Service Letter No. 422

SUBJECT: Rework of Propeller Spinner Assembly

MODELS AFFECTED: PA-30 Twin Comanches, Serial Nos. 30-1 to 30-348 inclusive

SKETCH A  
KIT 756 796  
Spinner Attachment

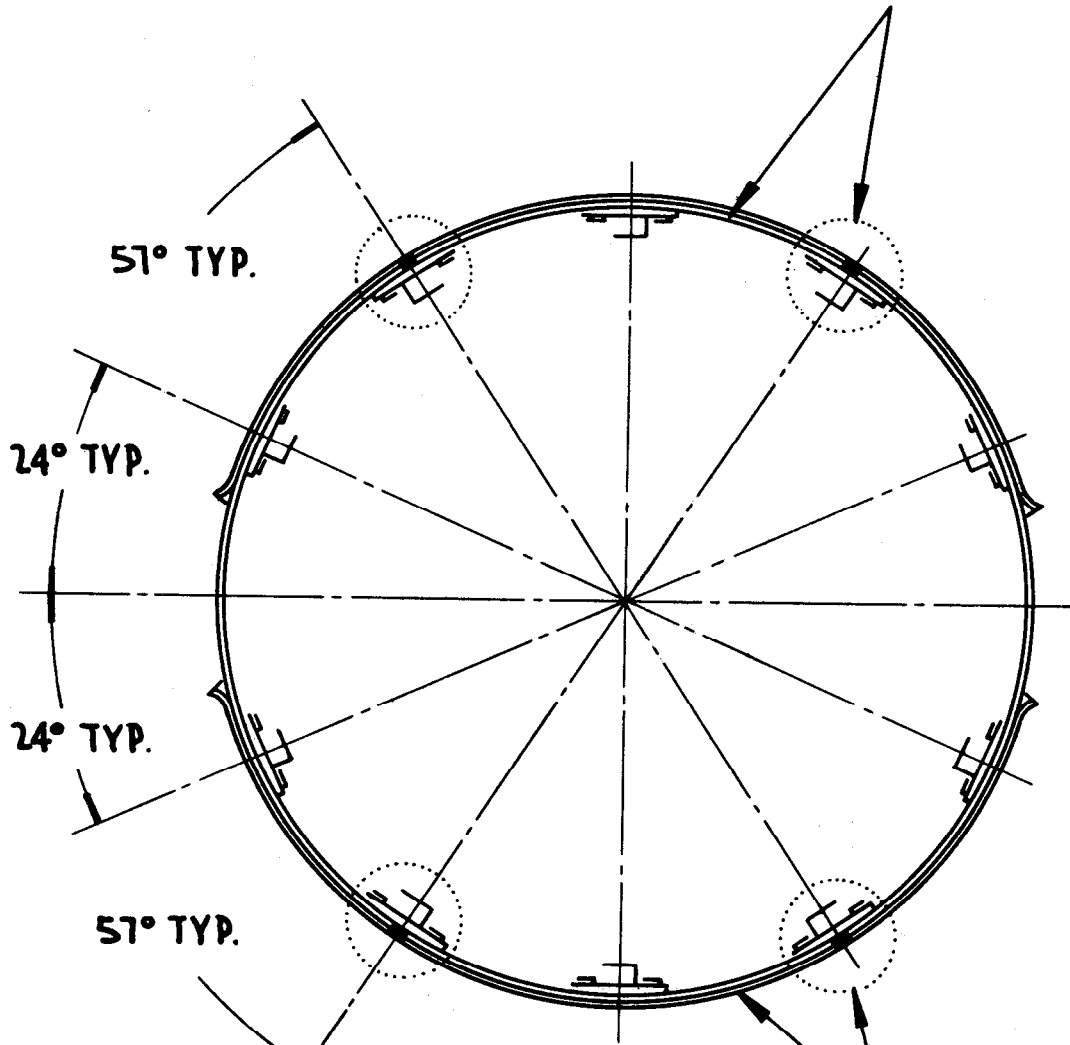
We have had reports which indicate that the propeller spinner attaching screws on the subject aircraft are chafing the spinner. In some cases the screw head had chafed sufficiently to wear through the spinner.

In order to correct this situation we have added four (4) additional screws to each spinner. These screws are installed midway between existing screws. Refer to sketch on the reverse side of this service letter.

.189/.191 HOLE (4 REQ.)  
ANCHOR NUT NAS686A3 (4 REQ.)  
RIVET AN426AD3-4 (8 REQ.)  
(ADD TO 23815 BULKHEAD ASSY.)

.189/.191 HOLE (4 REQ.)  
(ADD TO 23818 SPINNER ASSY.)

SCR. AN526-1032D8 (4 REQ.)  
(AT INST.)
